**SUQUEHANNA STEAM ELECTRIC STATION
RESPONSE TO REQUEST FOR ADDITIONAL
INFORMATION REGARDING SUPPLEMENTAL
RESPONSE TO GENERIC LETTER 96-06
DATED JULY 26, 2001
PLA- 5352**

**Docket Nos. 50-387
and 50-388**

RAI Responses

Figure 1 Drywell Temperature Profiles for Small Break LOCA Accident (SBA) and Loss of Drywell Cooling (LODWC).

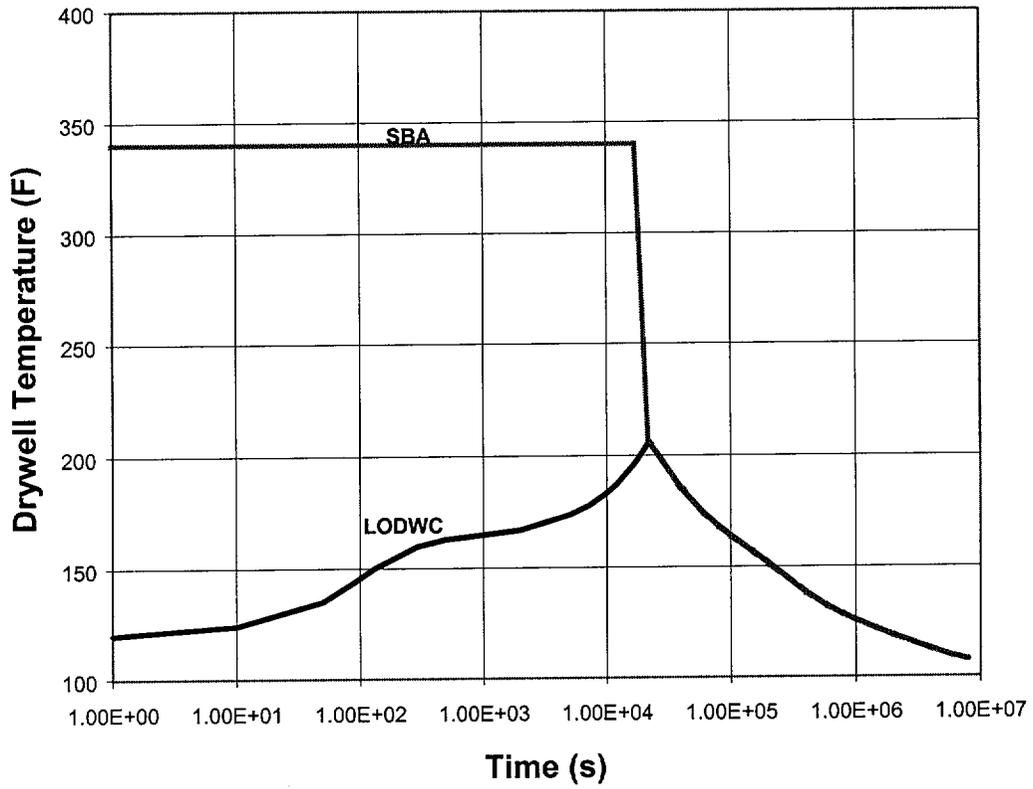
Provide further justification for P[3] - containment heating causes heating and expansion of the water trapped between the isolation valves over-pressurizing the pipe until rupture. At a minimum, please, address additional failure modes such as station blackout and human reliability.

Figure 1 shows the temperature profile associated with the small break LOCA. This temperature profile bounds all other temperature profiles including large break LOCA and Loss of Drywell Cooling. The Loss of Drywell Cooling event provides the bounding temperature for all non-LOCA MSIV closure events such as Station Blackout. The analysis results described in the responses to questions 7 and 8 show that no penetration experiences an increase in internal pressure sufficient to cause a pipe failure for the bounding small break LOCA temperature profile.

The only operator action assumed in the analysis is the initiation of shutdown cooling six hours after the small break LOCA. Emergency operating procedures direct the operators to initiate shutdown cooling. It is expected that the 98 psig interlock will clear in 3-4 hours after the event occurs. Thus the 6-hour assumption bounds the expected time for initiation of shutdown cooling. Operation of shutdown cooling prior to 6 hours will shorten the time in which the drywell is at the peak temperature shown in Figure 1.
